NOTICE OF VIOLATION

Duke Power Company  
McGuire Units 1 and 2

ENFORCEMENT CONFERENCE SUMMARY

## VC OUTSIDE AIR INTAKES

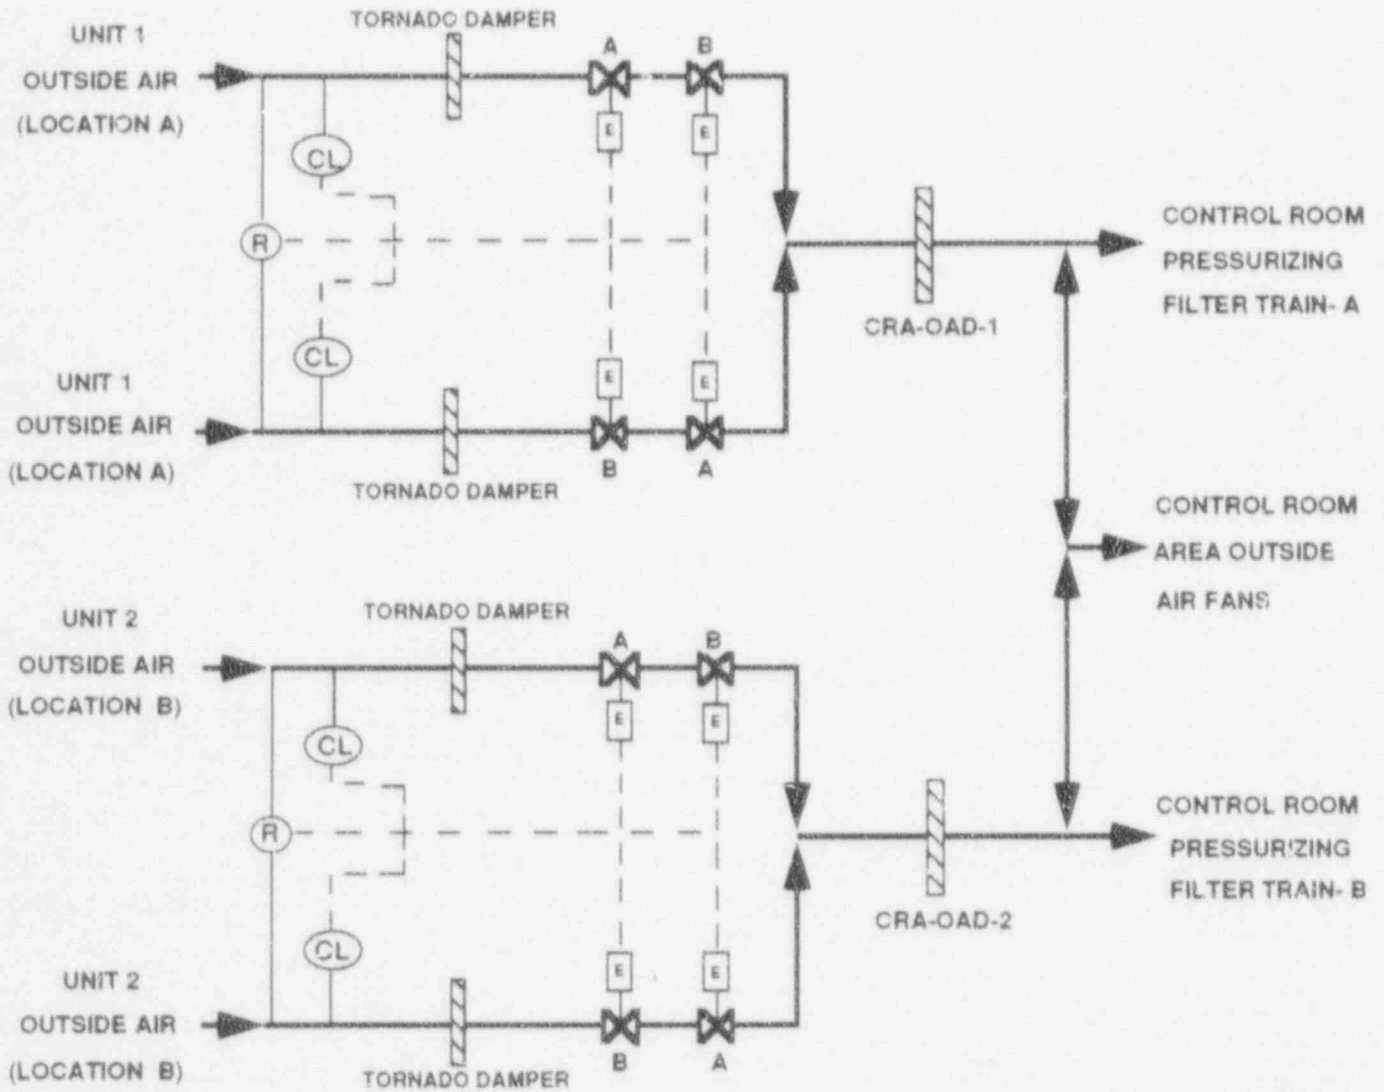
- \* ALL VC SYSTEM OUTSIDE AIR INTAKES AT BOTH CNS AND MNS CAN AUTOMATICALLY ISOLATE UNDER CERTAIN CONDITIONS RESULTING IN LOSS OF CONTROL ROOM PRESSURIZATION

- \* TIME REQUIREMENTS TO MANUALLY RE-OPEN OUTSIDE AIR INTAKES ARE NOT IN CONFORMANCE WITH ASSUMPTIONS OF CONTROL ROOM DOSE ANALYSIS

- \* IMMEDIATE CORRECTIVE ACTIONS (MNS)
  - ASSURED CONTROL ROOM PRESSURIZATION BY DELETING AUTOMATIC INTAKE ISOLATION.
  - INSTITUTED MANUAL ACTION TO CLOSE INTAKES IF ISOLATION NEEDED.
